Amendment Report

Snowy 2.0 Transmission Connection Project
(March 2022)

Figure 3-1 Overview of the amended project

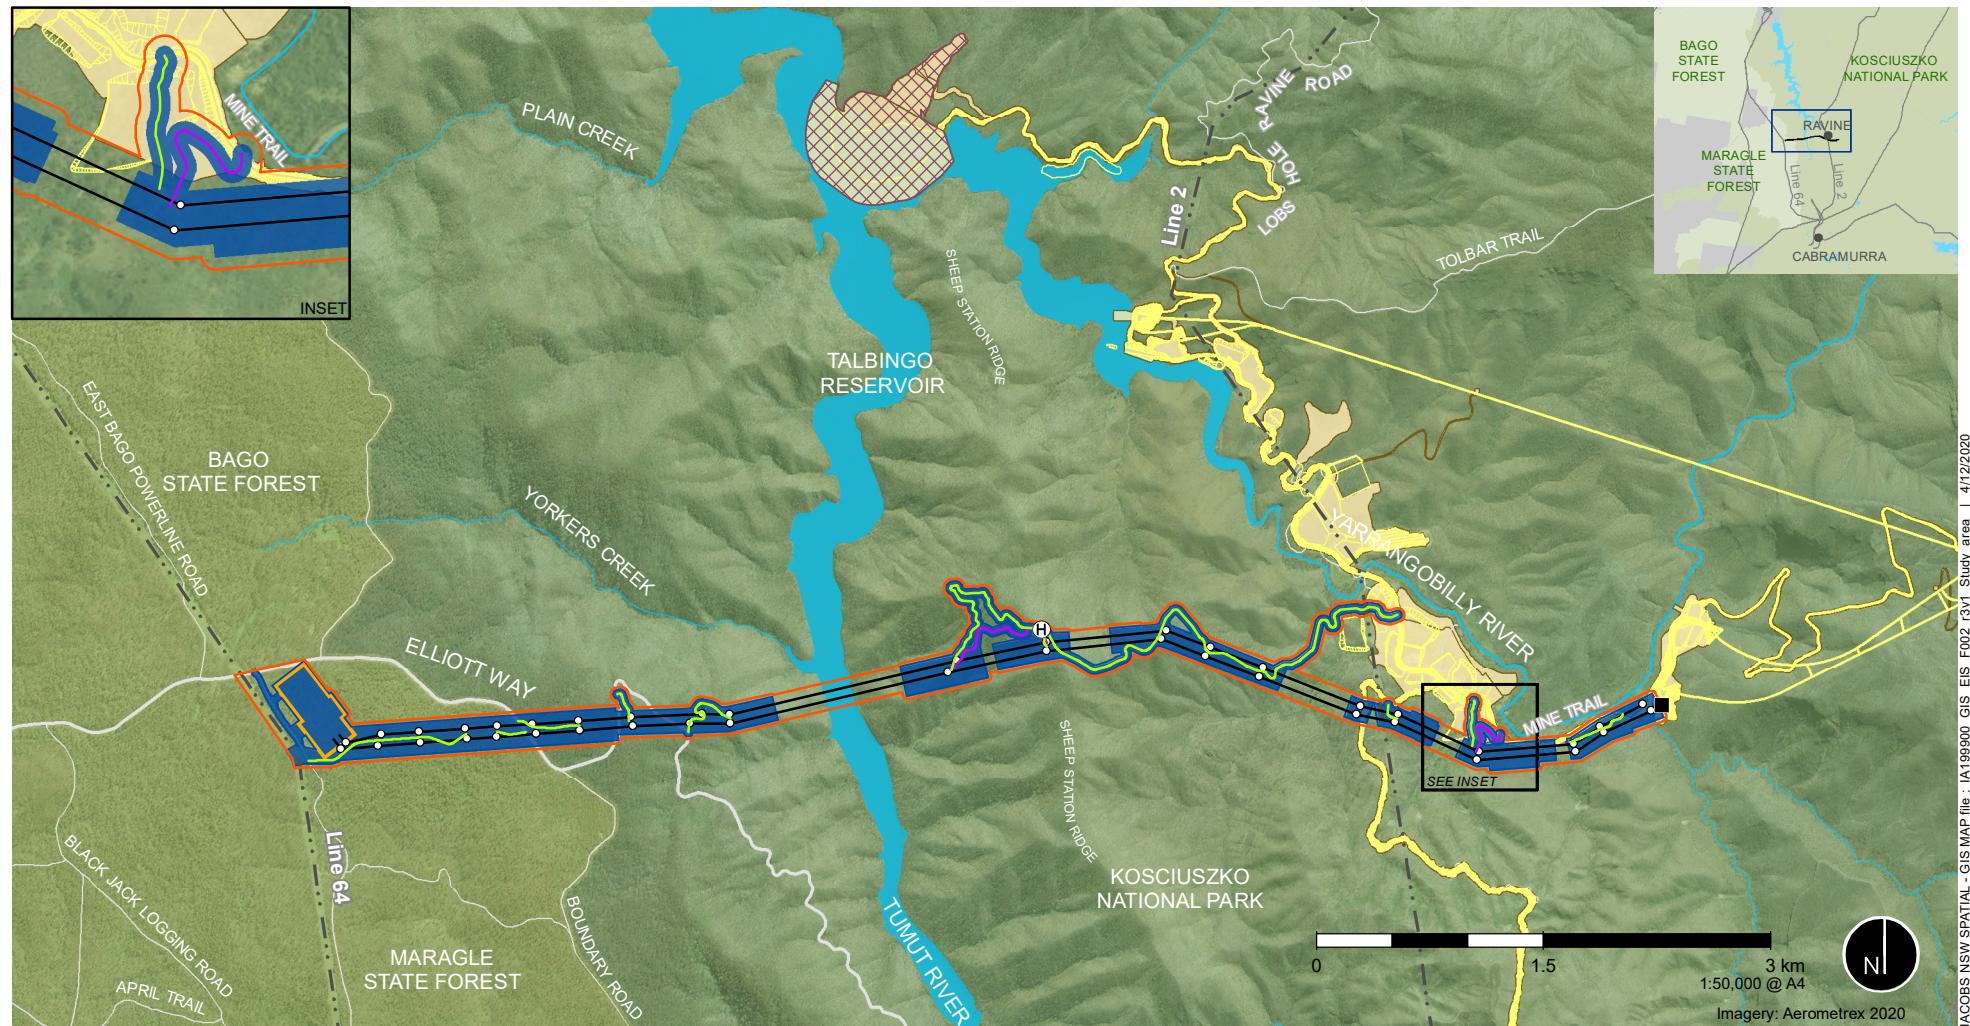
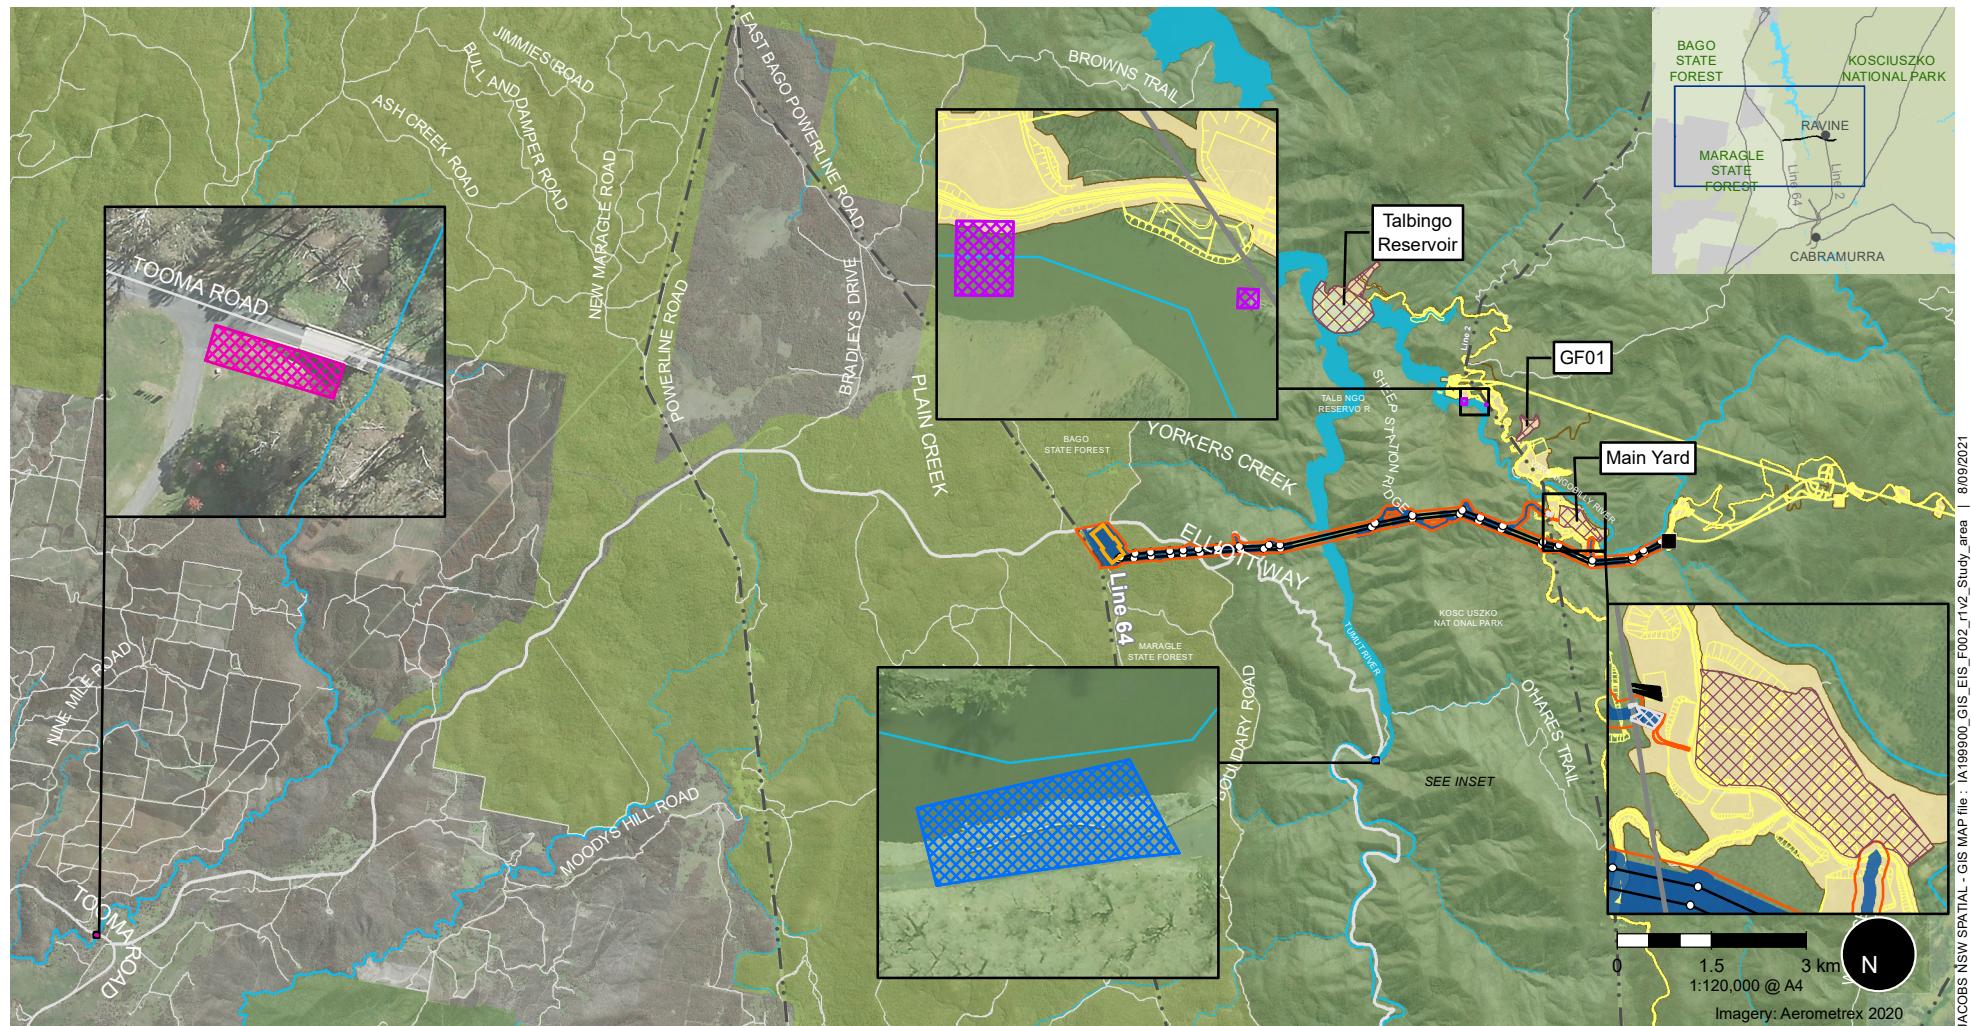
Transgrid has reduced the project disturbance footprint from approximately 143 hectares to approximately 125 hectares. This approximate 12.6% reduction was achieved through refinement of the access tracks and transmission connection corridor by reducing the width of the cleared easement and hazard tree areas using Light Detection and Ranging (LiDAR) analysis. The refined project area and reduced disturbance is shown in **Figure 3-1**.

As a result of the reduced disturbance area, the amended project would directly impact about 118.27 hectares of native vegetation. This would include complete clearing of about 71.03 hectares of native vegetation and partial clearing of about 47.24 hectares.

Figure 3-2 | Management zones within the disturbance area

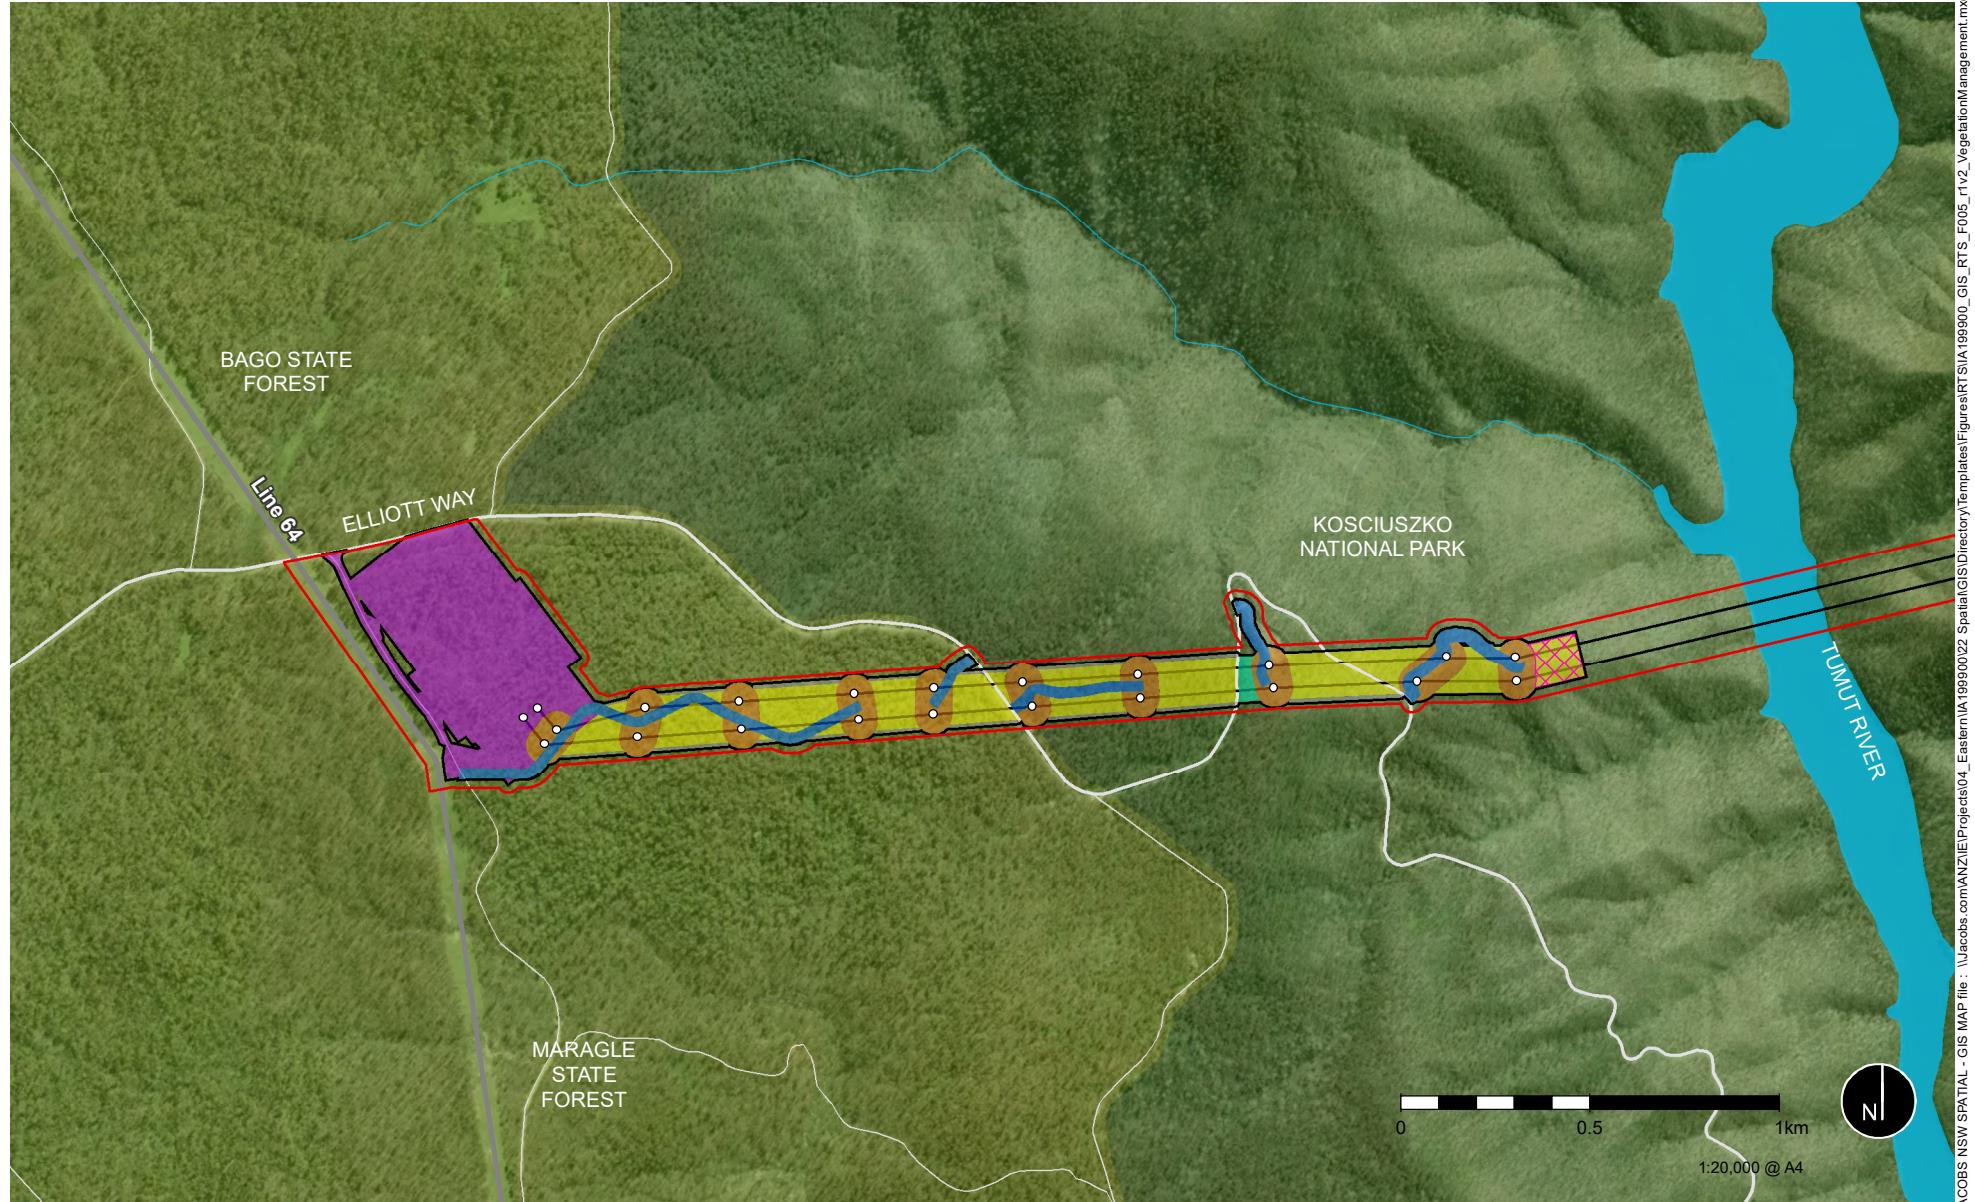
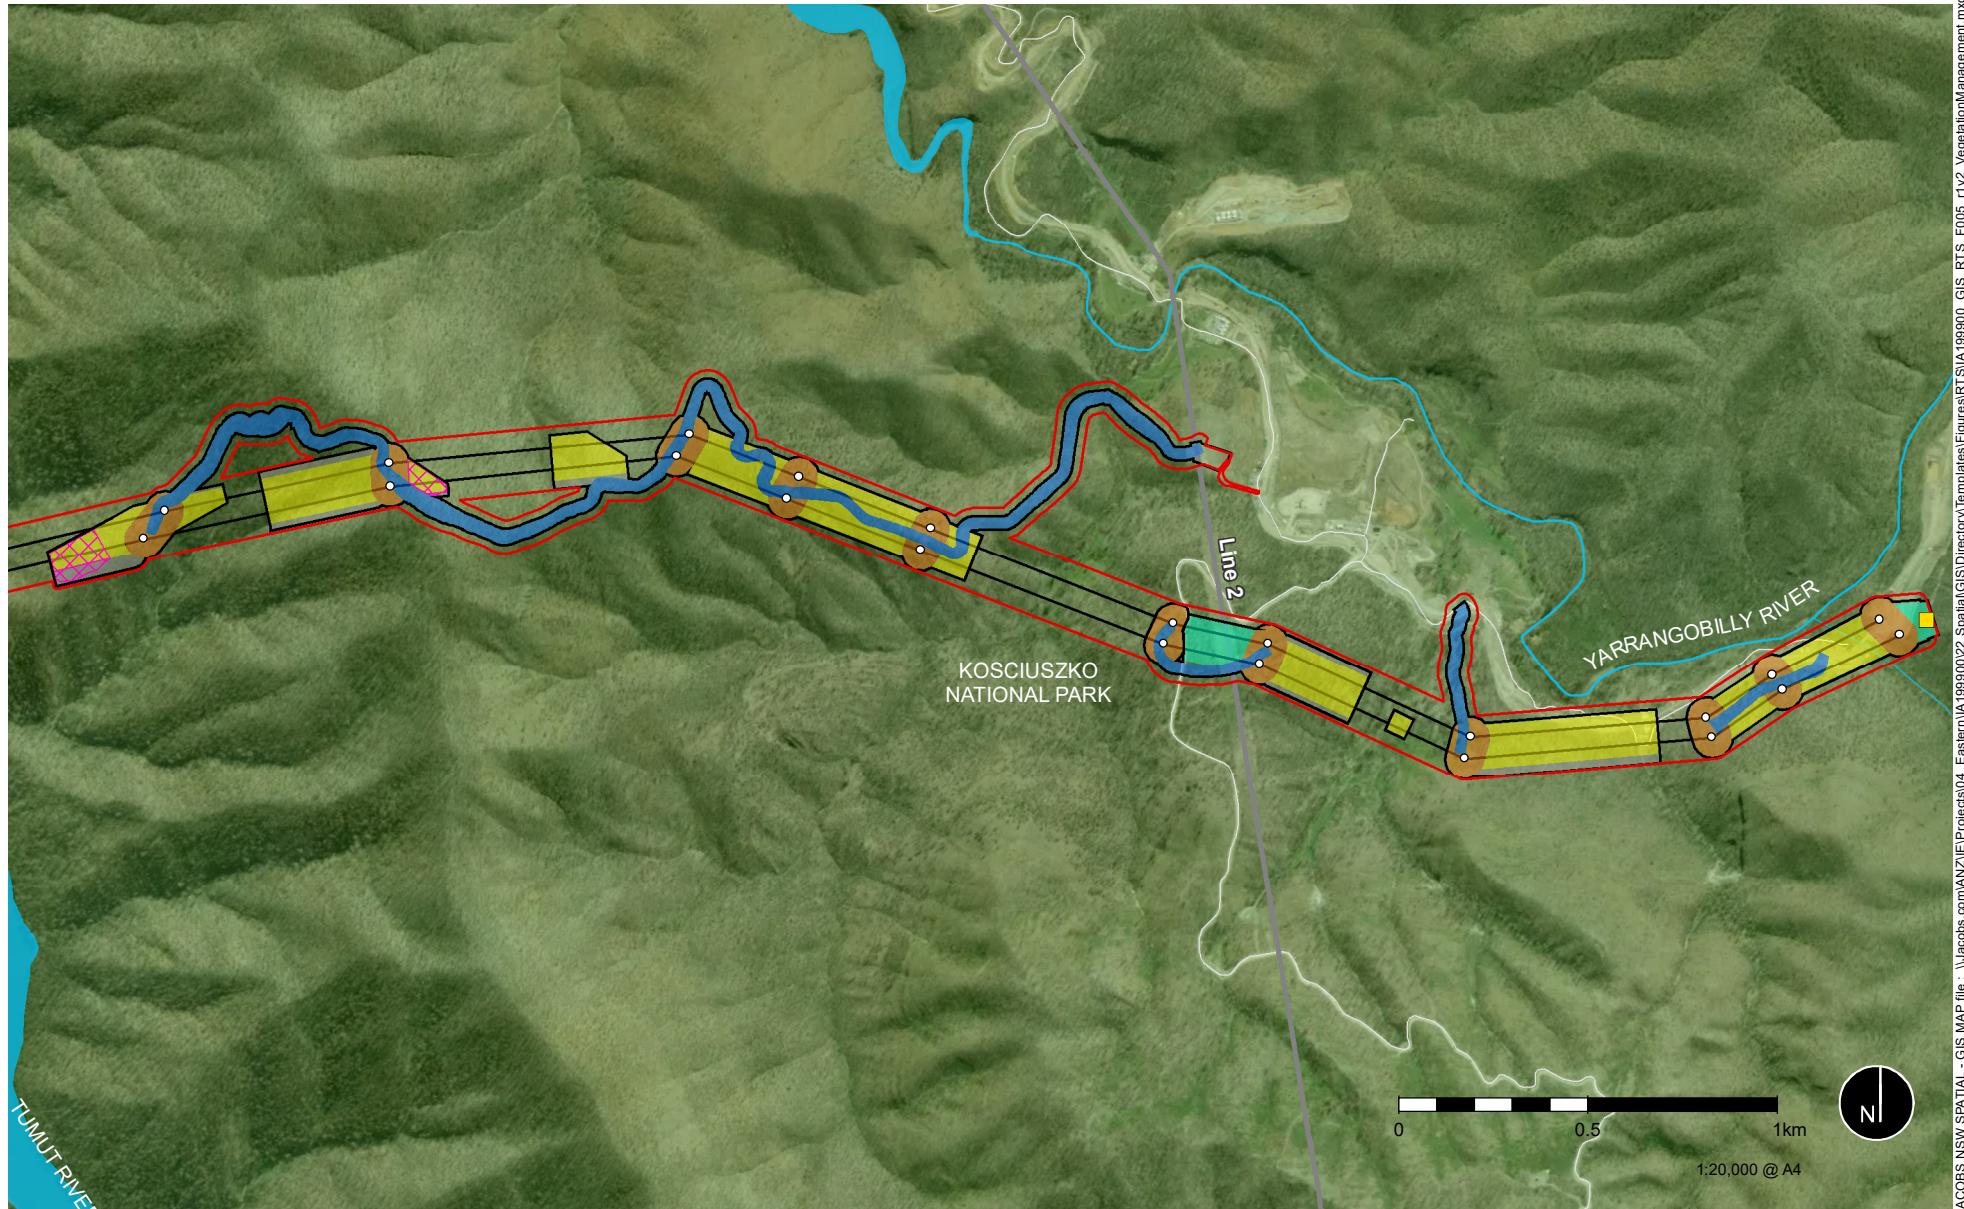
The reduced disturbance area has been split into six management zones. Each of these management zones would be subject to specific clearing requirements as part of construction of and during ongoing operational maintenance of the project. The six management zones as shown on **Figure 3-2** are the:

Four of the management zones (TSZ, TPZ, ATZ and SZ) would require full clearing of the zone, while two management zones (ECZ and HTZ) would require partial clearing. The clearing methodology for each of these management zones is discussed further in **Section 3.3.4**, with the biodiversity impact presented in the revised BDAR provided in **Appendix C** and summarised in **Section 6.2**.

Figure A-1 Indicative substation layout

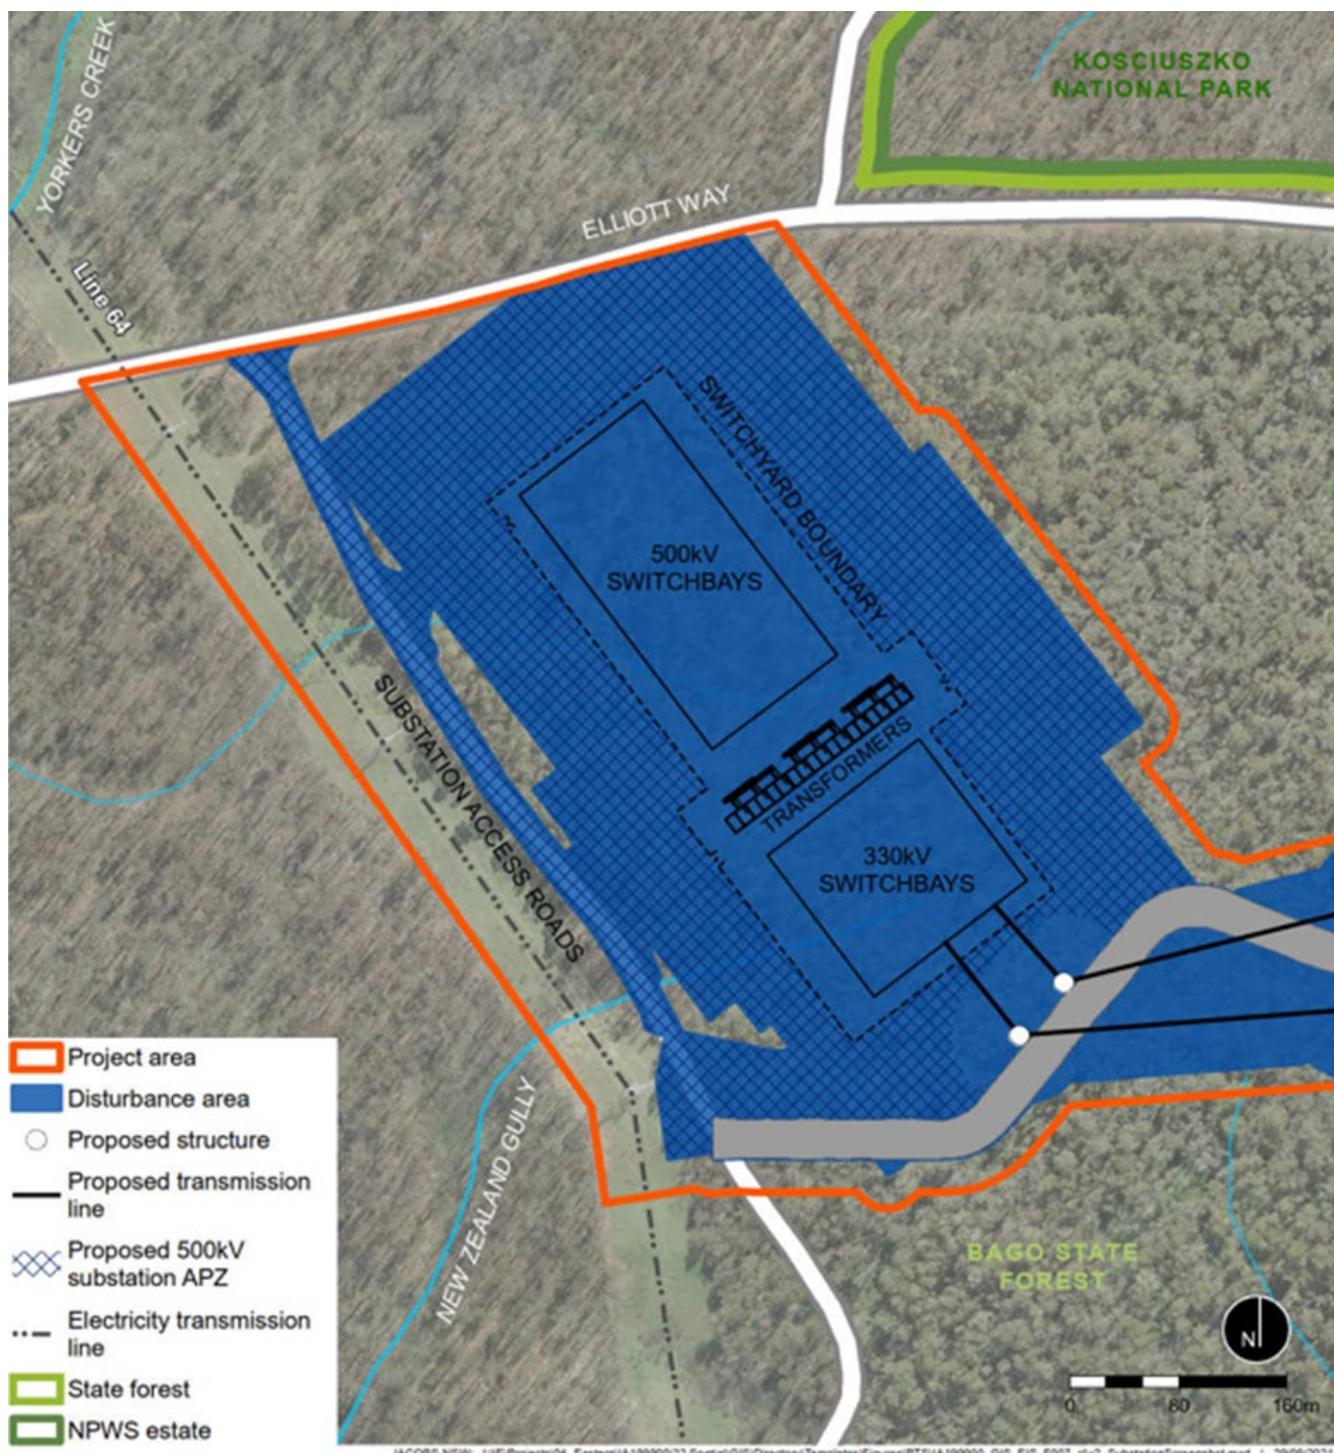
The substation footprint has been increased for the APZ to meet compliance with *AS5339-2018 Construction of buildings in bushfire prone areas*. As such, the substation footprint would be about 230 metres wide by 530 metres long, surrounded by an approximate 80 metre to 100 metre wide APZ. The indicative substation layout is shown on **Figure A-1**. The increased substation footprint has been captured in the overall reduced disturbance footprint as shown on **Figure 3-1**.
